**CITY OF BELMONT  
PLEASANTS COUNTY, WEST VIRGINIA  
CONTRACT #3 – WATER STORAGE TANK  
ADDENDUM #1  
JULY 26, 2024  
THRASHER PROJECT #T10-11028**

A Pre-Bid Conference was held on Tuesday, July 23, 2024 on the above-referenced project, a copy of the sign in sheet is included in this Addendum #1. The following are clarifications and responses to questions posed by contractors for the above-referenced project.

CITY OF BELMONT  
 WATER SYSTEM IMPROVEMENT PROJECT  
 WATER STORAGE TANK  
 WELDED STEEL TANK  
 PLAN AND ELEVATION

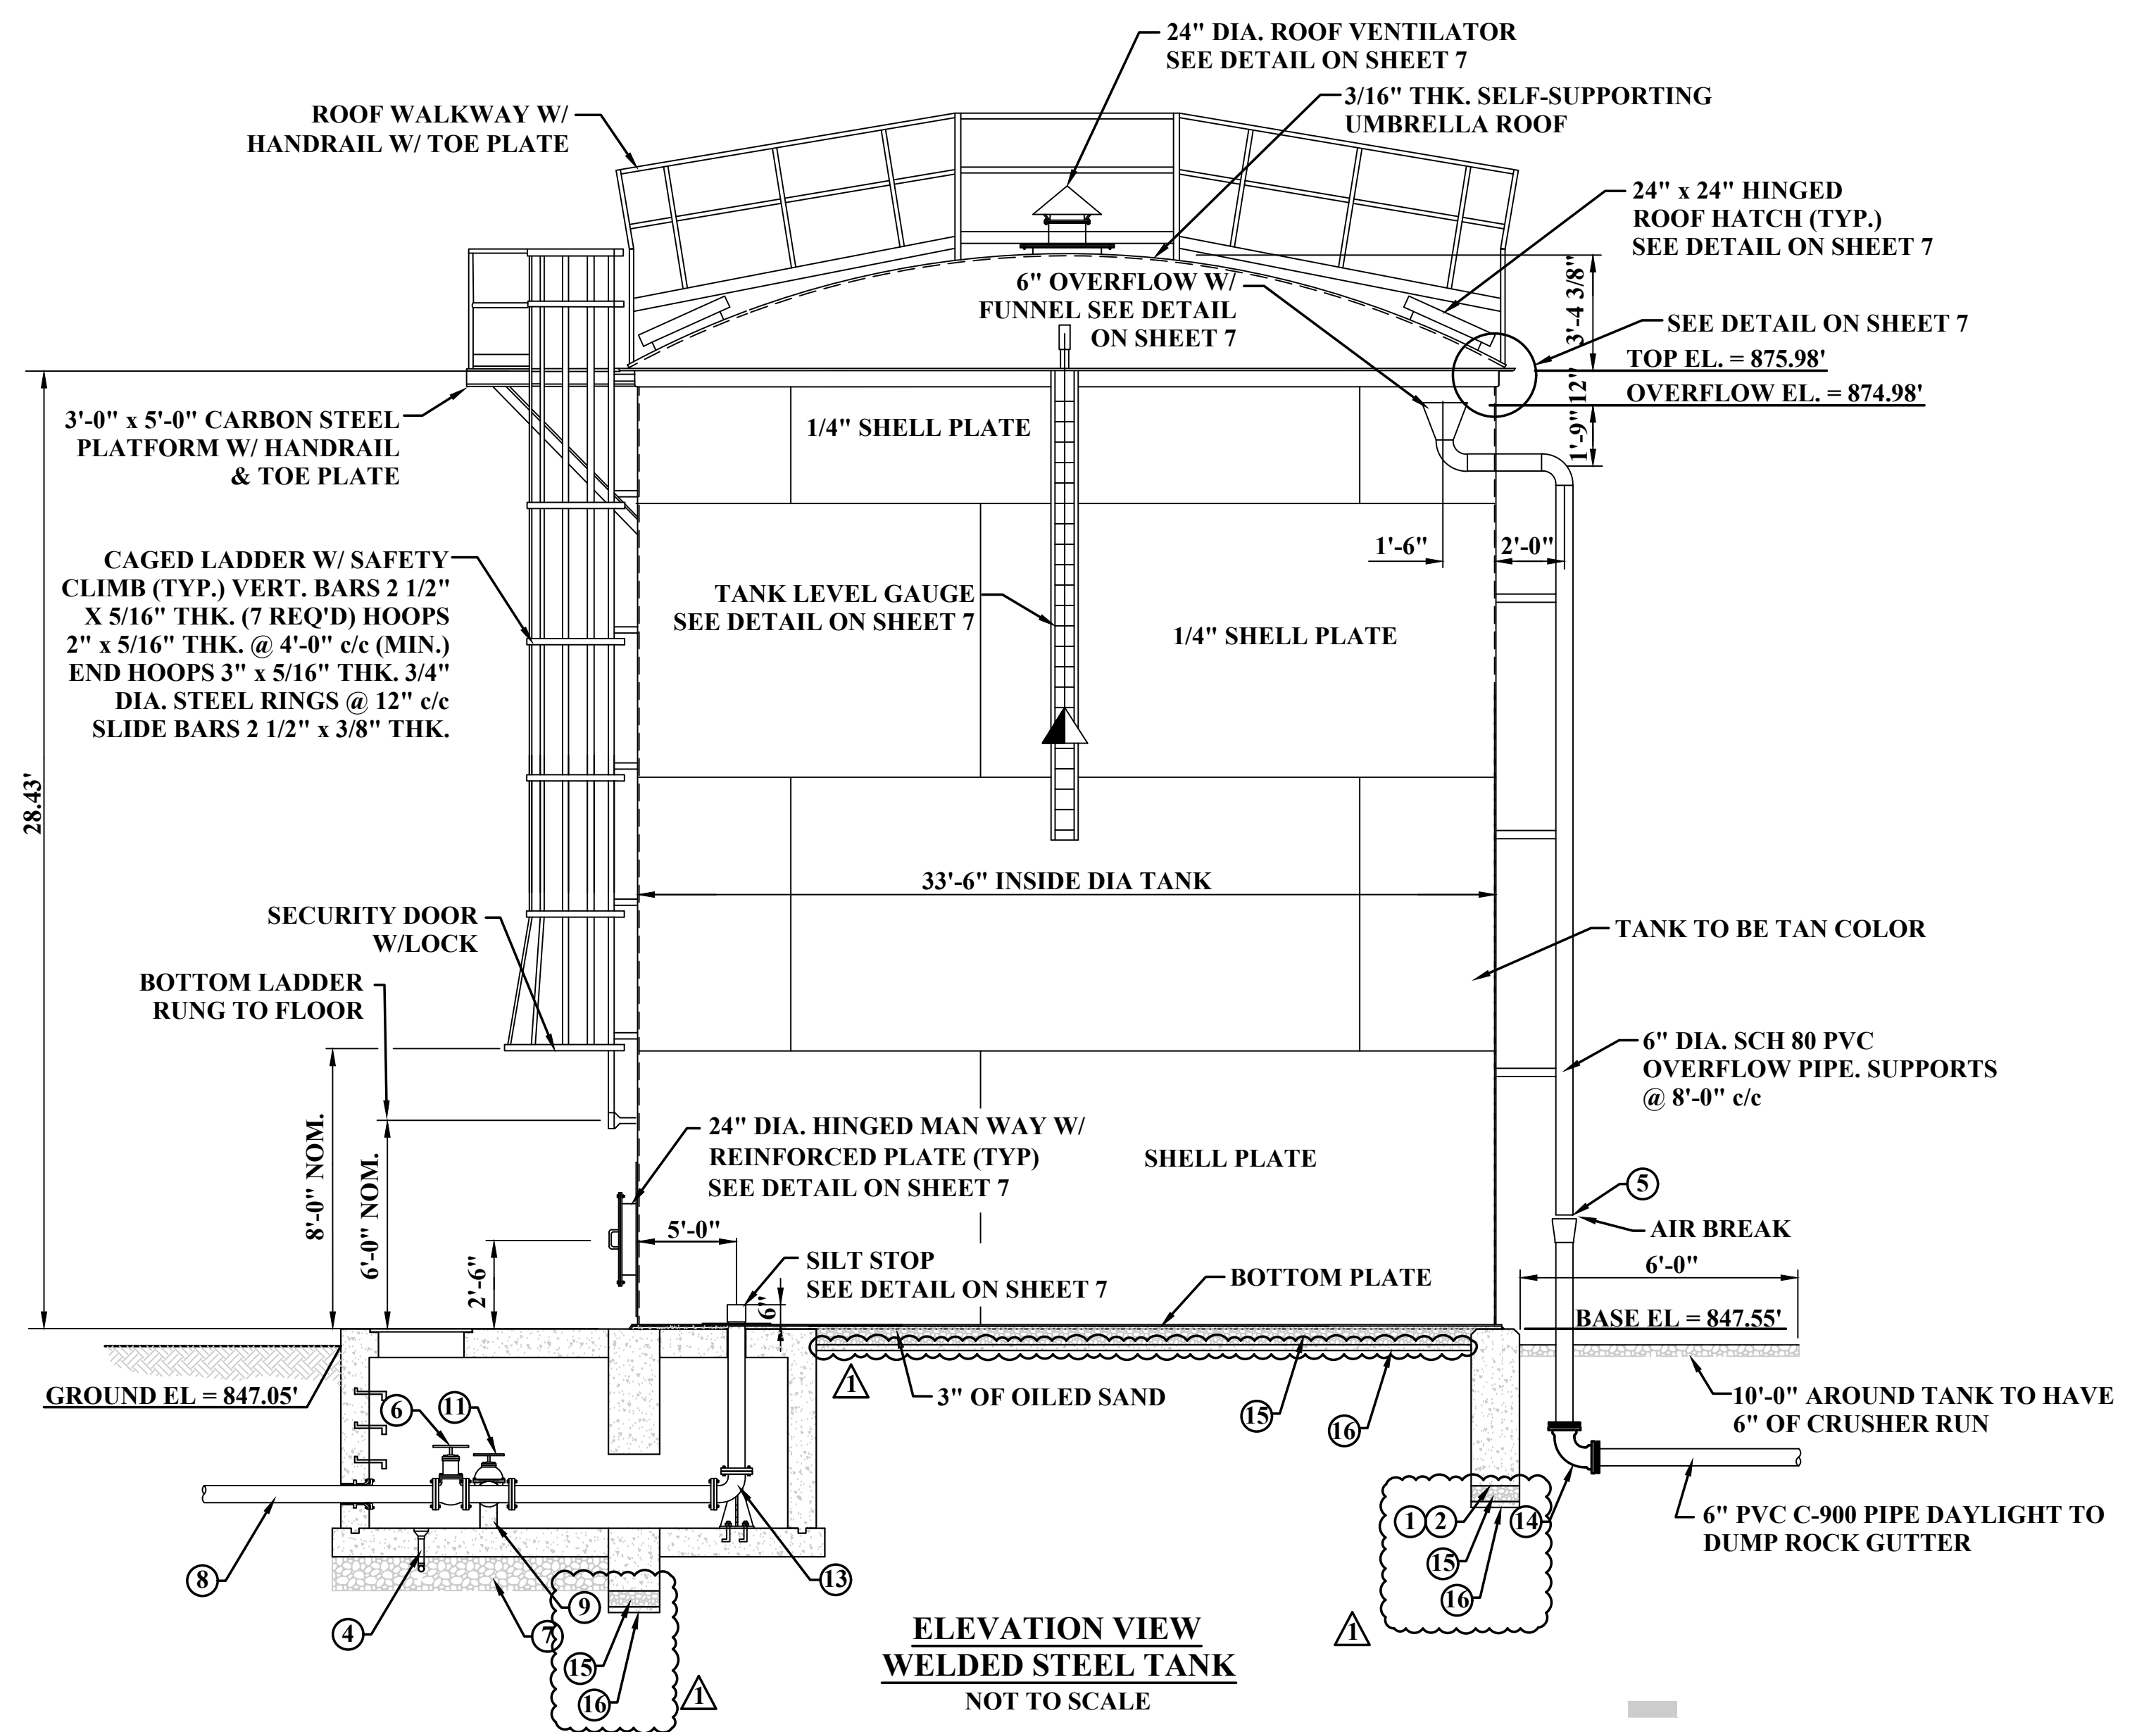
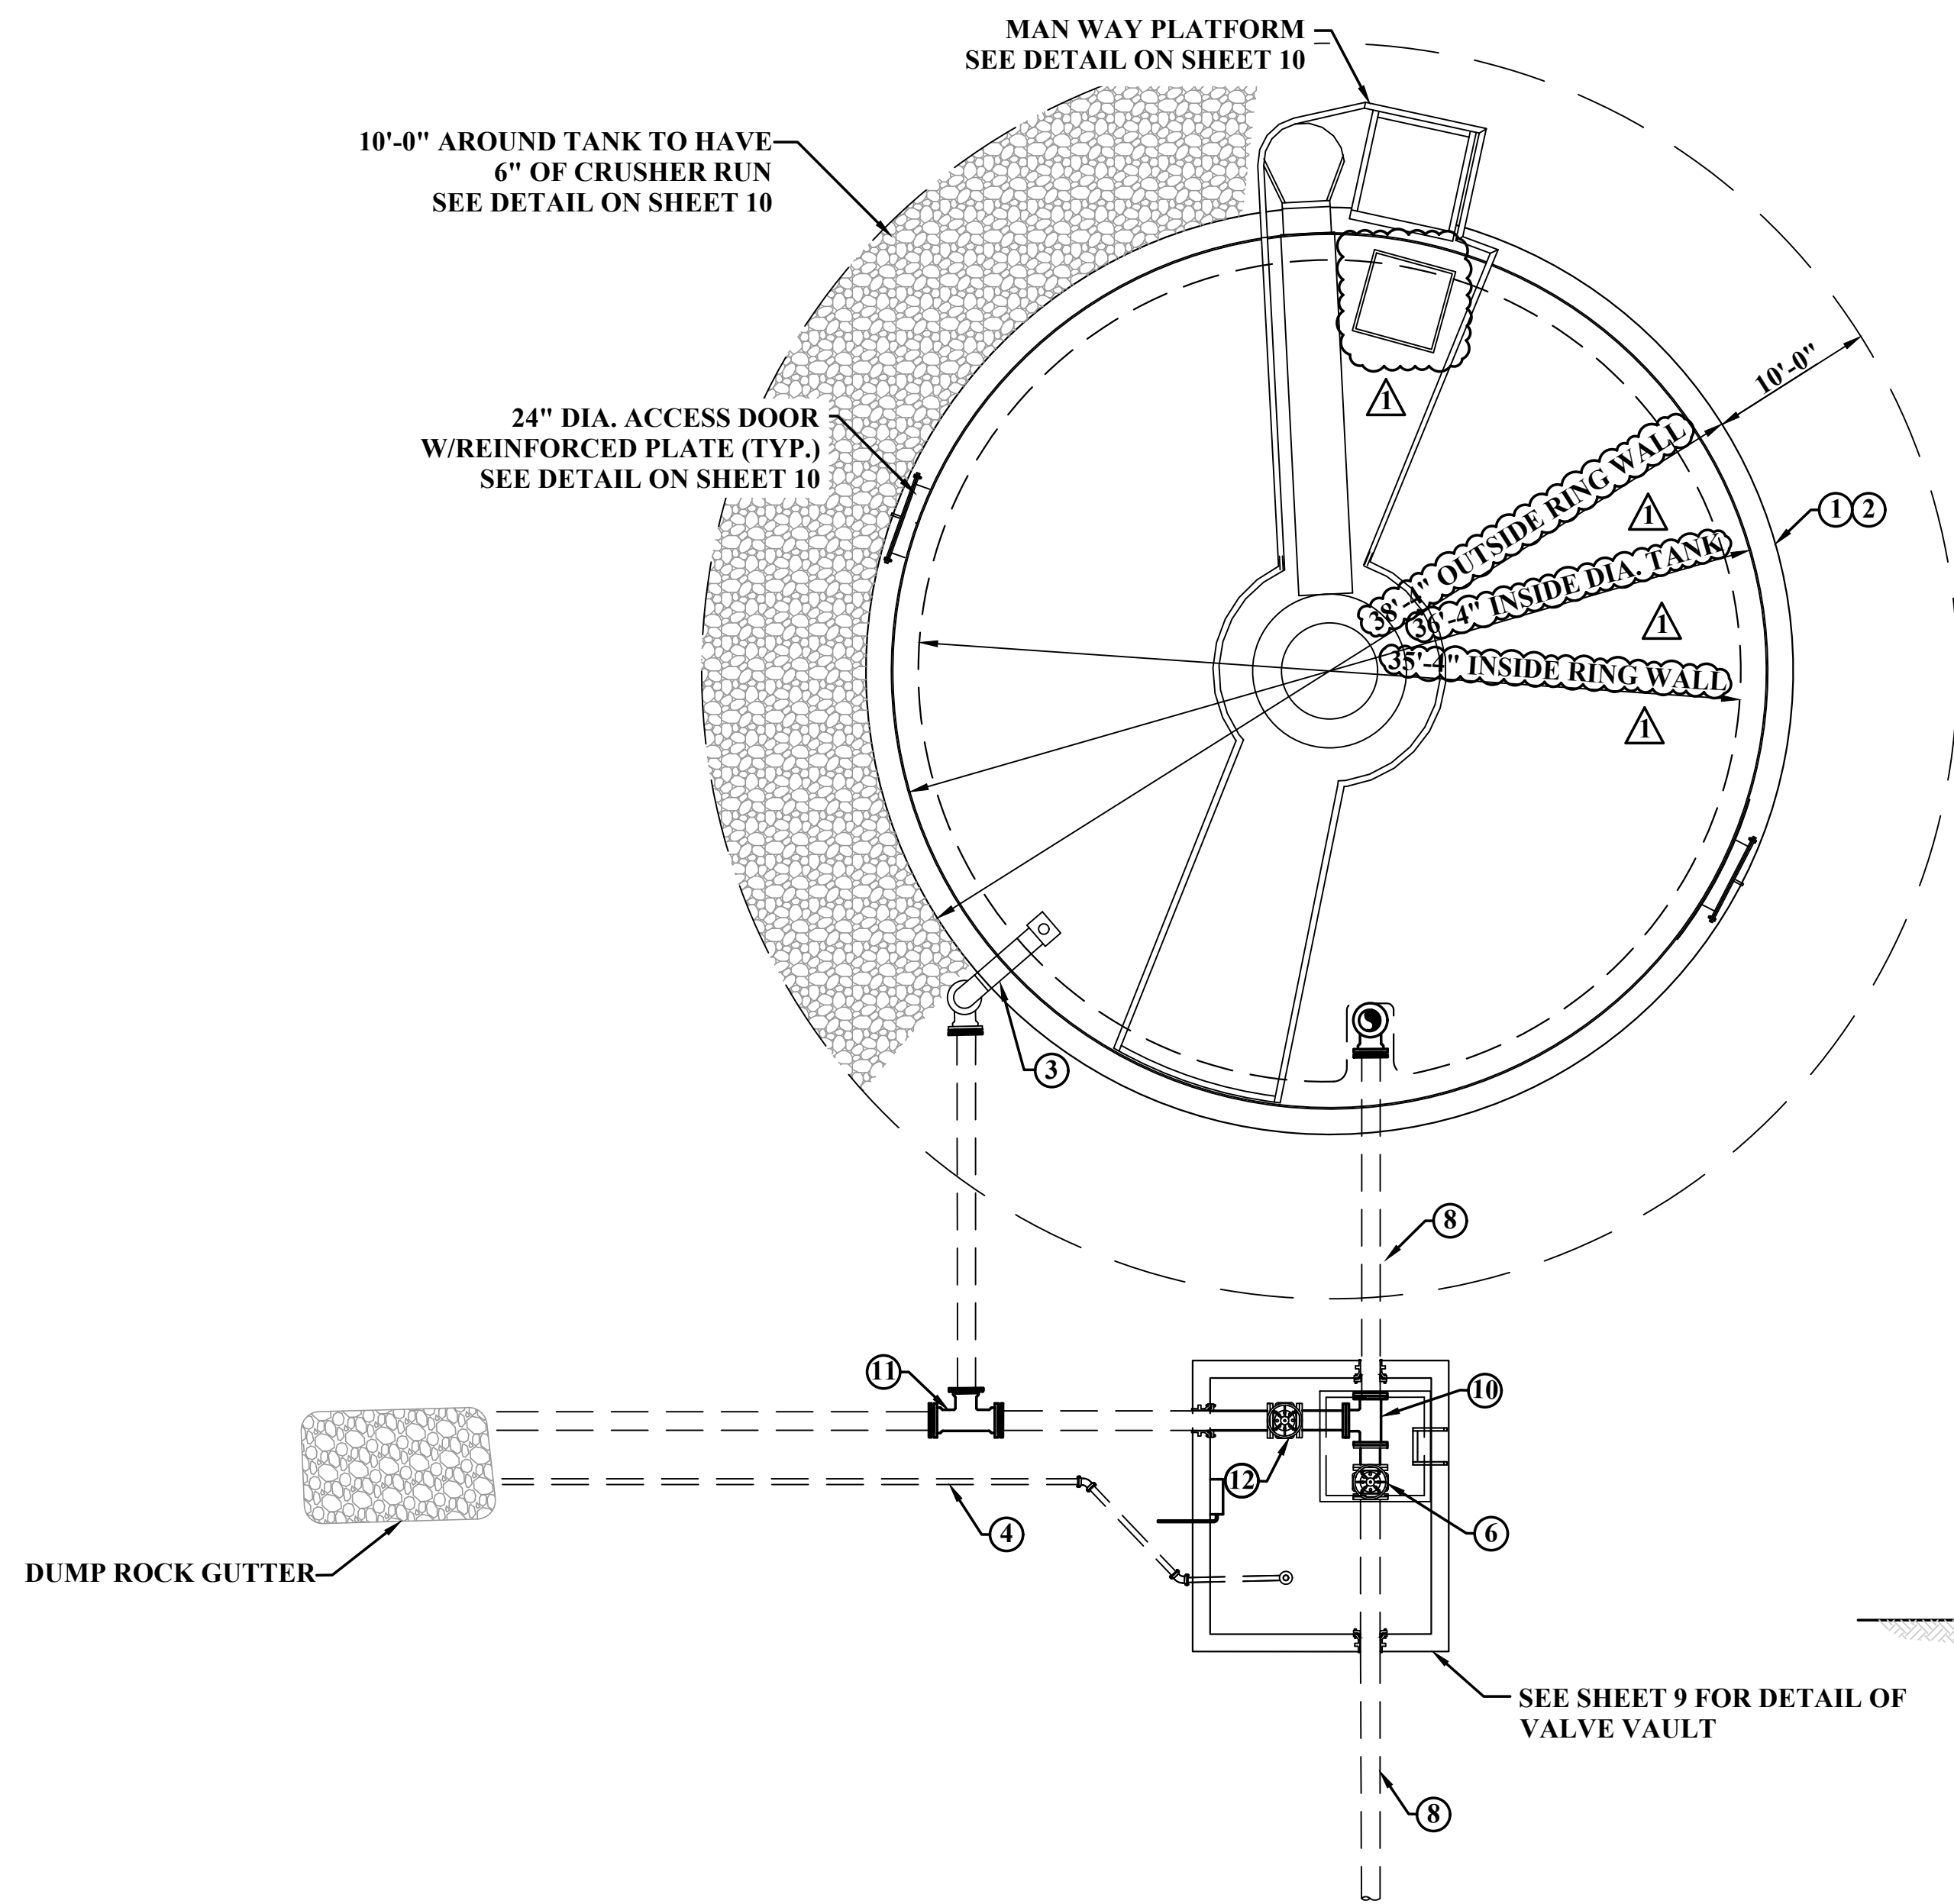
What is the Bottom Plate shown at the bottom of the tank on the Elevation View?

This has been removed.
